Response to Action Item 3-49.3

CLARIFYING QUESTIONS, DCD SECTION 3.4.1.3

Question No. 3 (AI 3-49.3): Identification of SSCs Subject to Flood Protection: DCD Tier 2, Section 3.4.1 states the following: *The reactor containment building systems to be protected from flooding are the reactor coolant system (RCS), safety injection system (SIS), reactor coolant gas vent system (RCGVS), and main steam system (MSS). The components to be protected from flooding are the valves and electric instrumentation of these systems.*

Figure 1.2-5 General Arrangement Reactor Containment Building El. 100'-0"

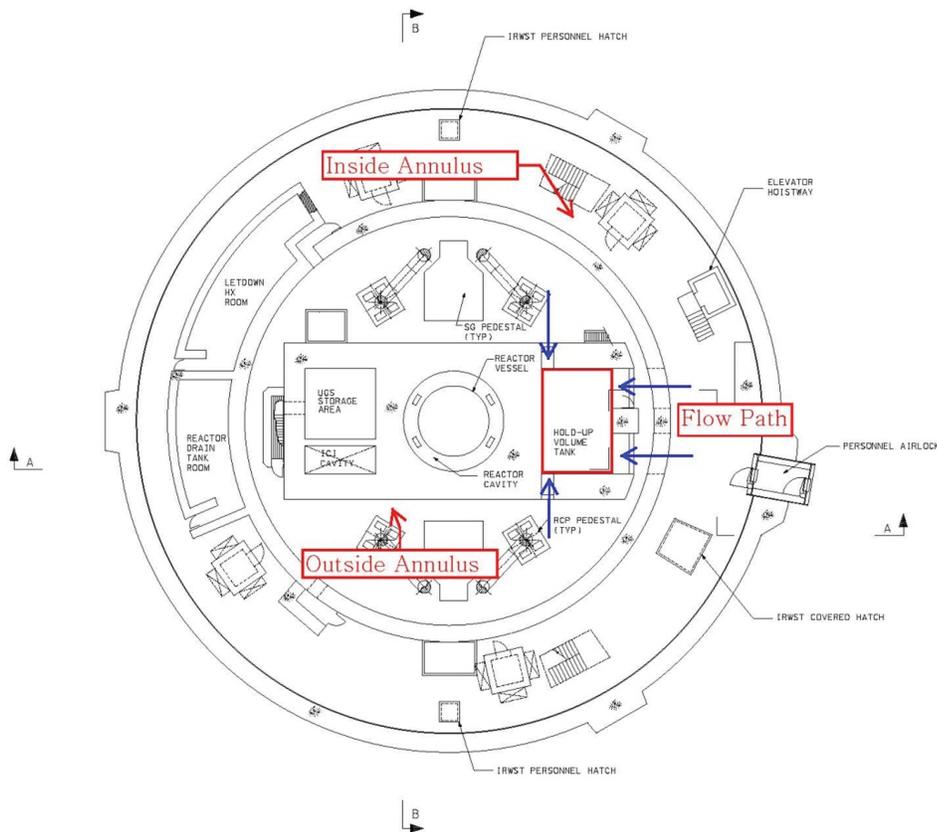
- c) Explain how the “2 ft” is determined. Is it applicable to all containment areas including annulus and areas outside annulus at EL. 100 ft.

The 2 ft is based on the volume of water from the LOCA up to 50 seconds applied to containment bottom area at El. 100 ft 0 in which includes the annulus area. The flood level areas outside the annulus, but inside containment building are shown in the drawing below.
